**Meridian Airport Authority, Dean Aircraft Services
Hangar Additions & Alterations**

ADDENDUM NO. 4

TO: All Bidders on the Above Referenced Product
FROM: Davis Purdy Architects, PLLC
DATE: March 17, 2020
SUBJECT: **ADDENDUM NO. 4**

E-002

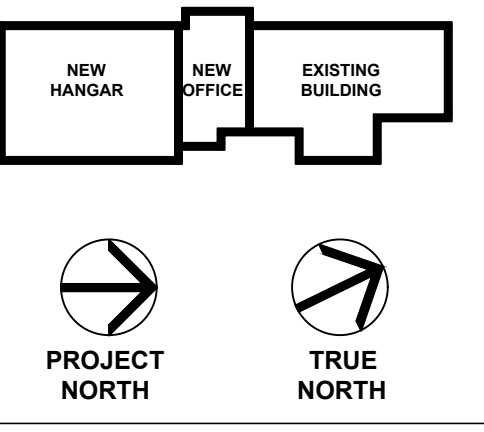
b. E-002 ELECTRICAL RENOVATION SITE PLAN

E-101

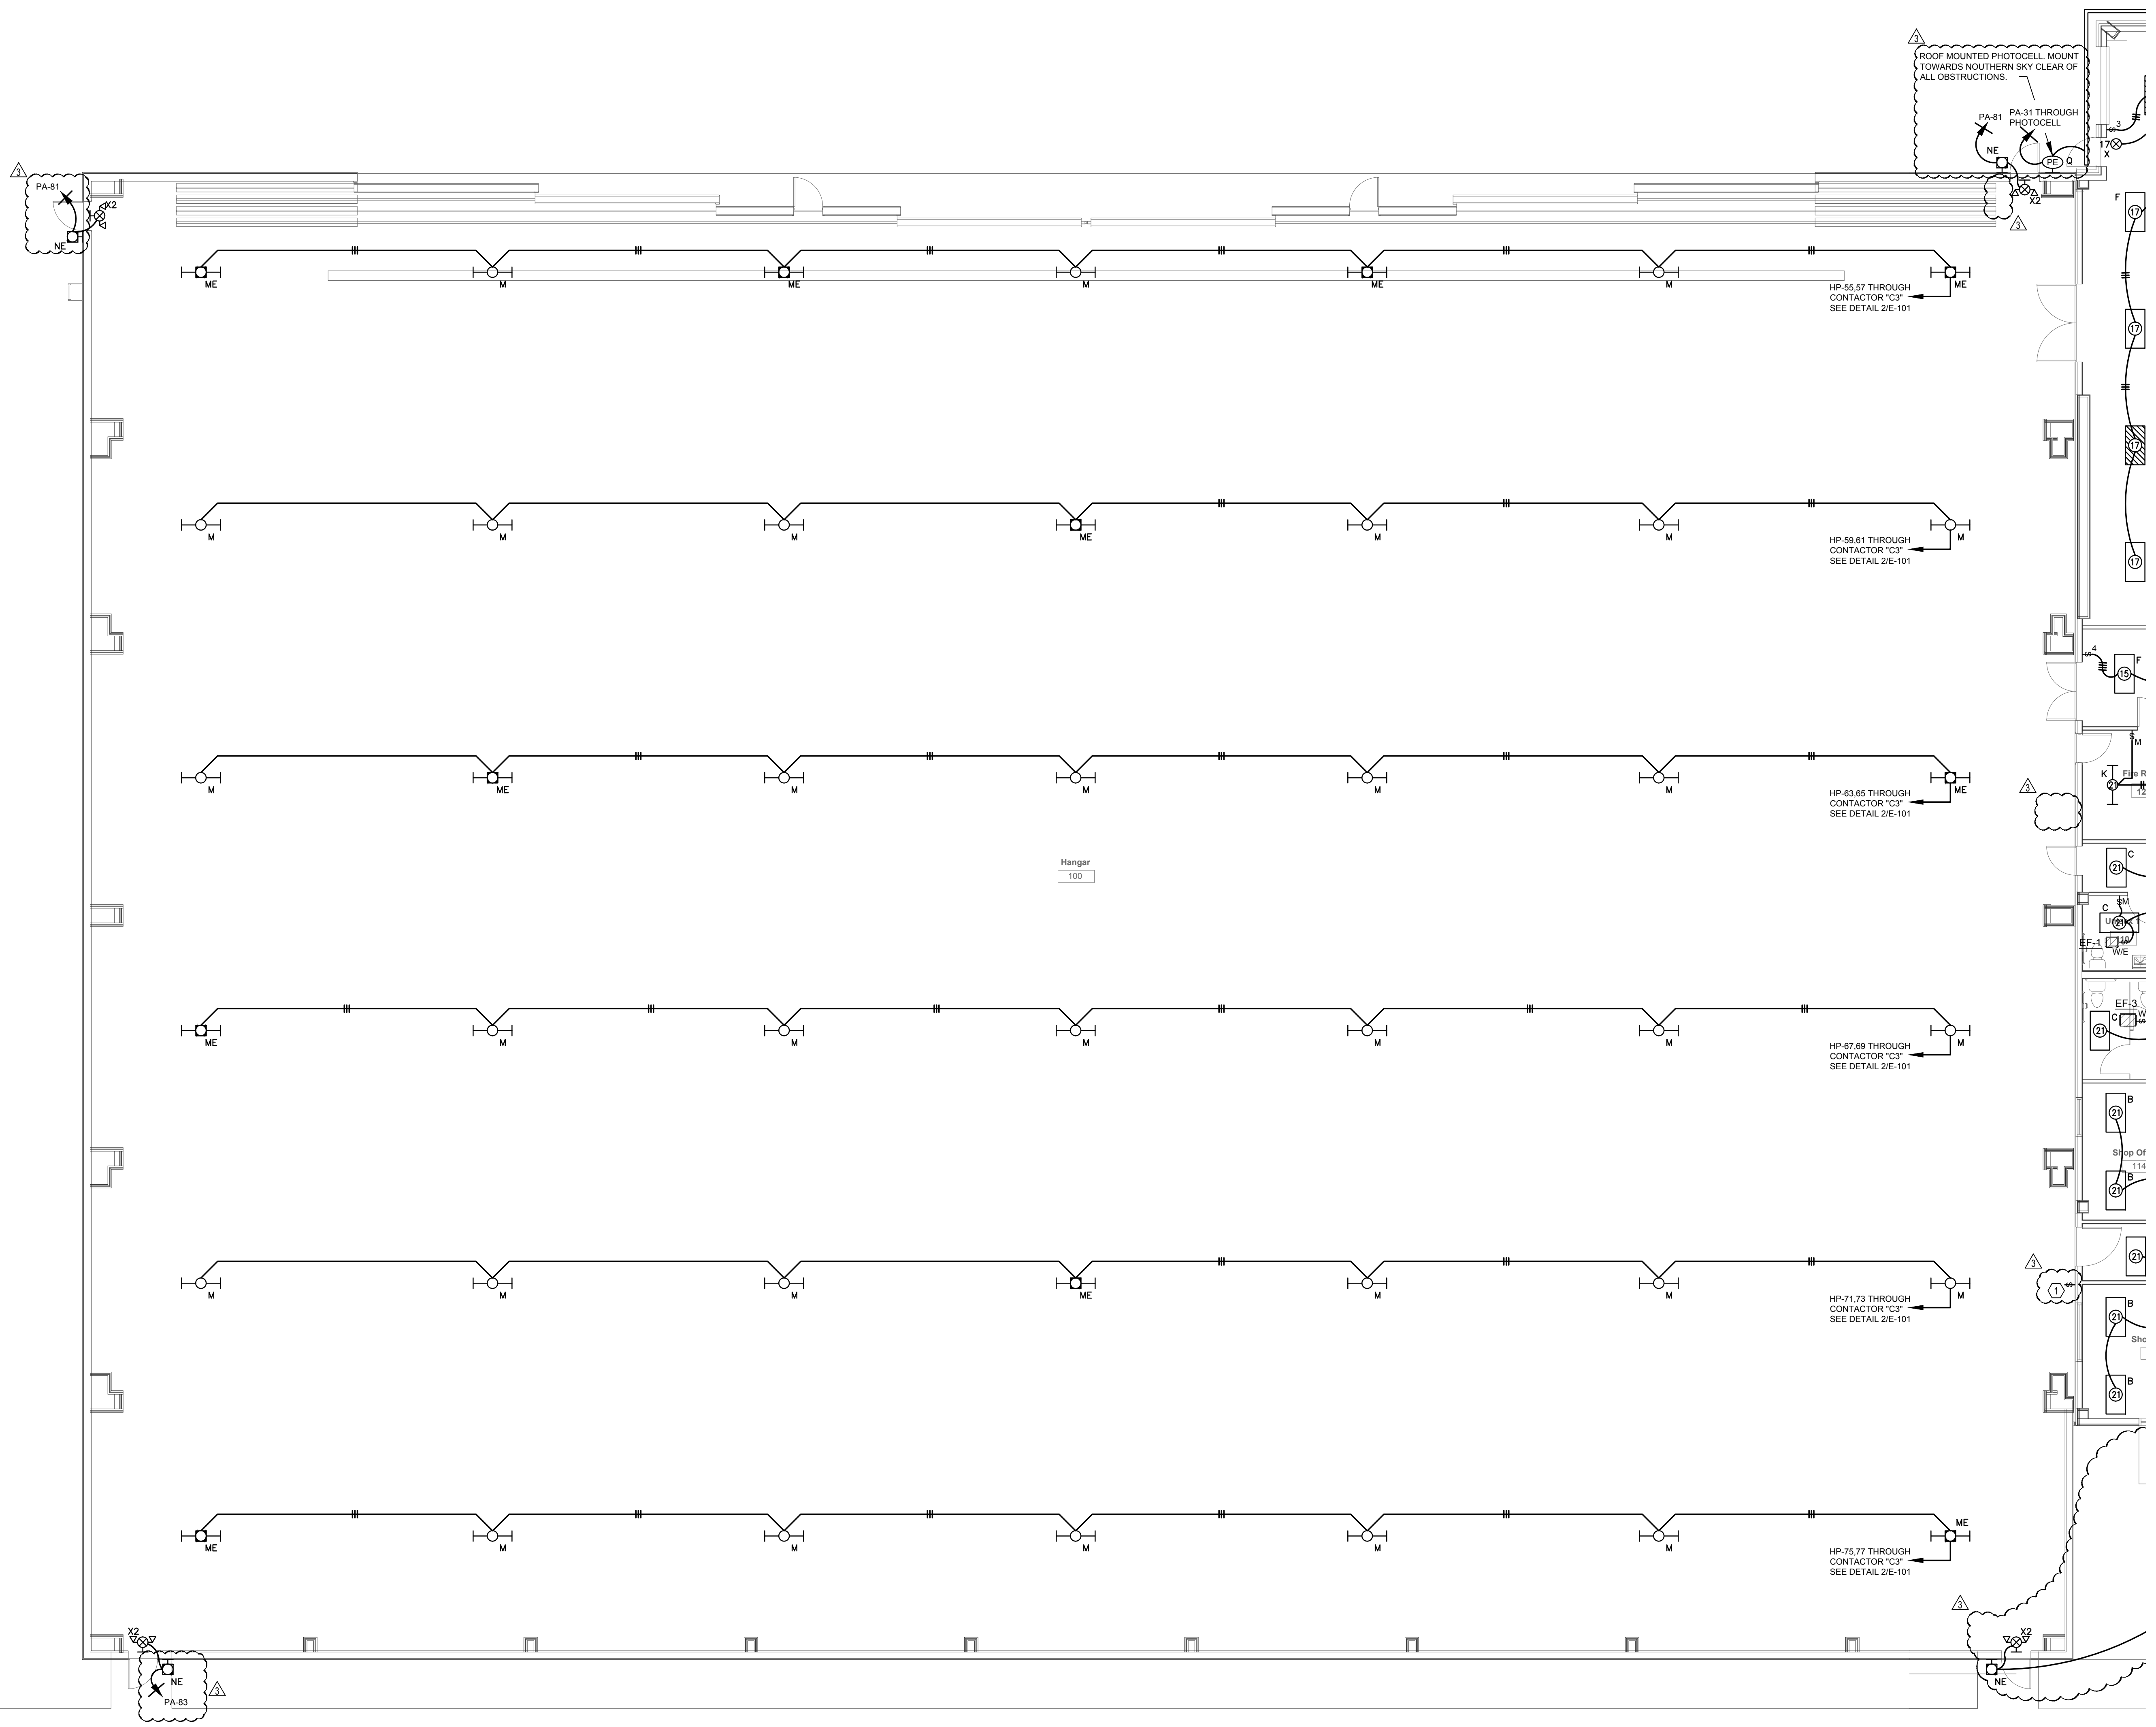
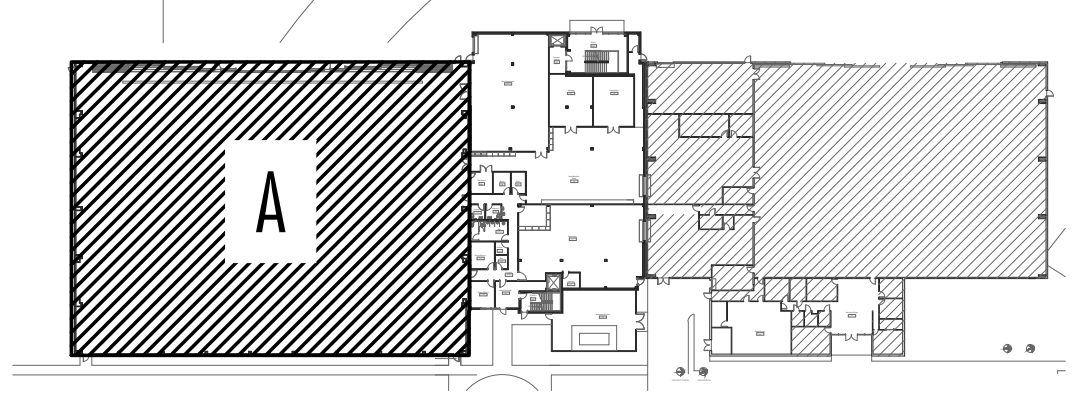
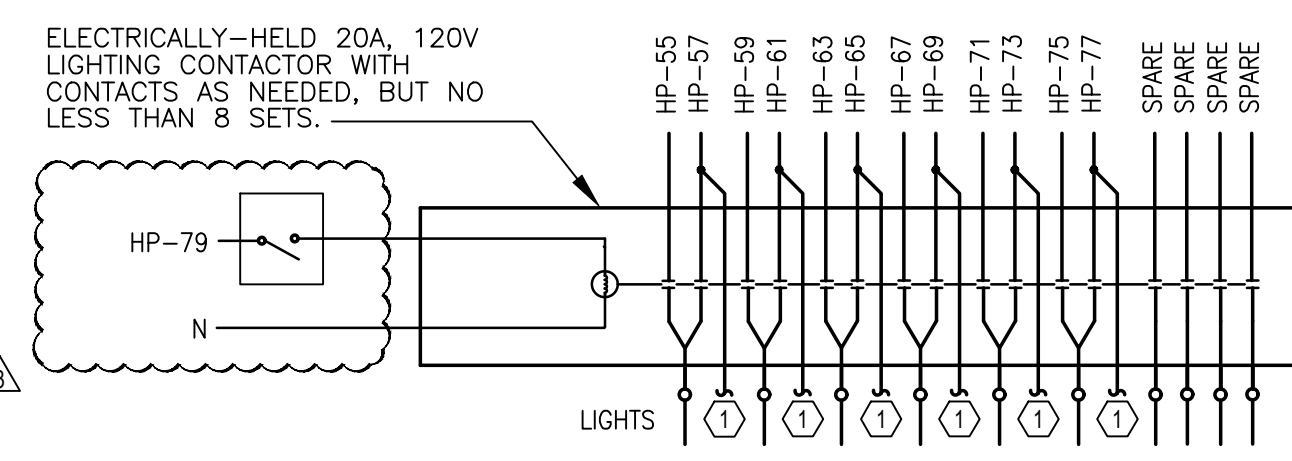
- c. E-101 PARTIAL LIGHTING PLAN 1ST FLOOR PART A**
 - i. Modified notes for exterior lighting controls, and added photocell to control exterior some exterior fixtures.

- ii. Modified how hangar fixtures are controlled. Modified Contactor detail to reflect this change.
 - d. E-102 PARTIAL LIGHTING PLAN 1ST FLOOR PART B**
